**RE: Nusenda Credit Union Admin Expansion  
Grading and Drainage Plan  
Engineer's Stamp Date 2/14/18  
Hydrology File: G16D154**

Based on the information provided in your submittal received 2/14/18, the Grading and Drainage Plan cannot be approved for Building Permit until the following comments are addressed:

**LOWER LEVEL GRADING and DRAINAGE PLAN**  
 date:  
 2-14-18  
 sheet:  
 c101

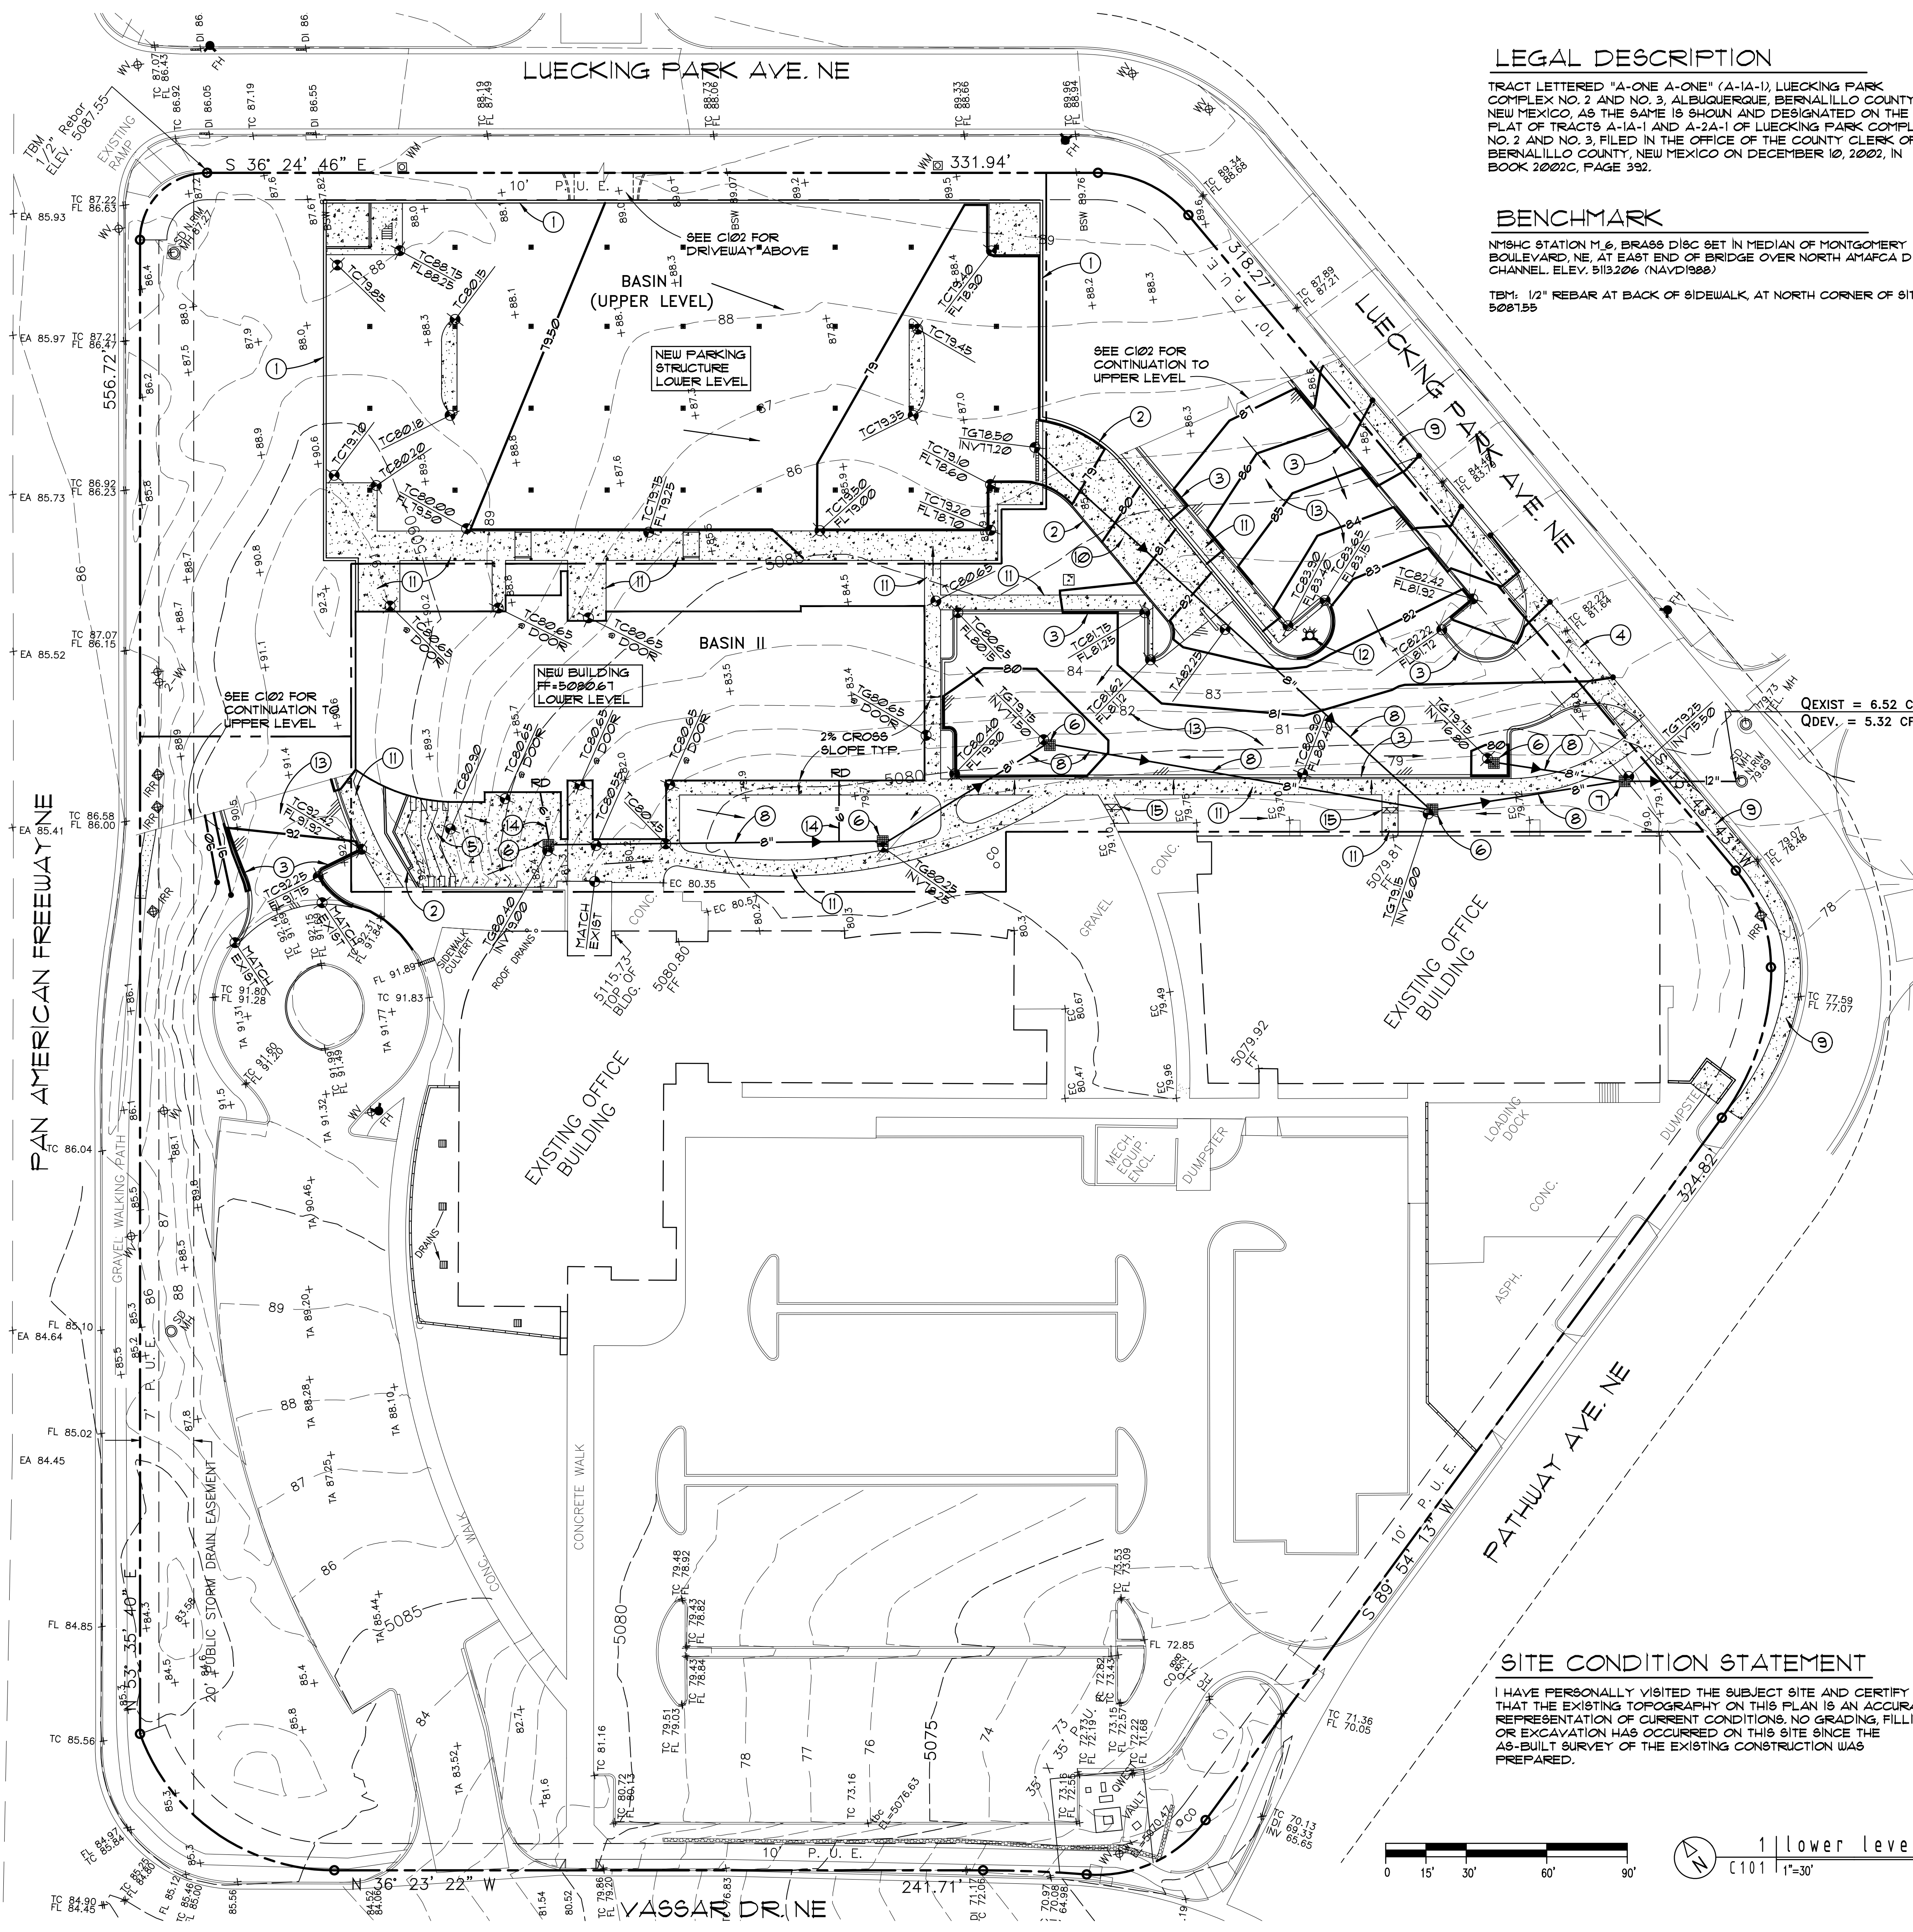
3. Are there any modifications or increases in runoff to Pan-American? If so, NMDOT approval is required.
4. Show the existing storm drain alignments along Pan-American and Luecking.

5. This project will require a public Work Order for the work along Luecking. Add a note to this grading plan that "No work is permitted in the Public Right-of Way without an approved Work Order" or similar.

6. Either a recorded SIA with financial guarantee or close-out of the public work order will be required prior to issuing Certificate of Occupancy.
7. Basin 2 appears to discharge to several areas: Basin 1, Pan-American, and Luecking. Please divide this basin and explain how each part of the site drains.

8. The new driveway and surrounding landscaping off of the cul-de-sac needs to be included in the site hydrology. Currently it does not appear to be a part of any of the basins.
9. The use of land treatment B is suspect. Compacted areas and sloped landscaping exceeding 10% are considered land treatment C. Please re-evaluate land treatments to be consistent with table A-4 of DPM Ch. 22.
10. This project requires an ESC Plan, submitted to the Stormwater Quality Engineer (Curtis Cherne PE, [ccherne@cabq.gov](mailto:ccherne@cabq.gov) or 924-3420).
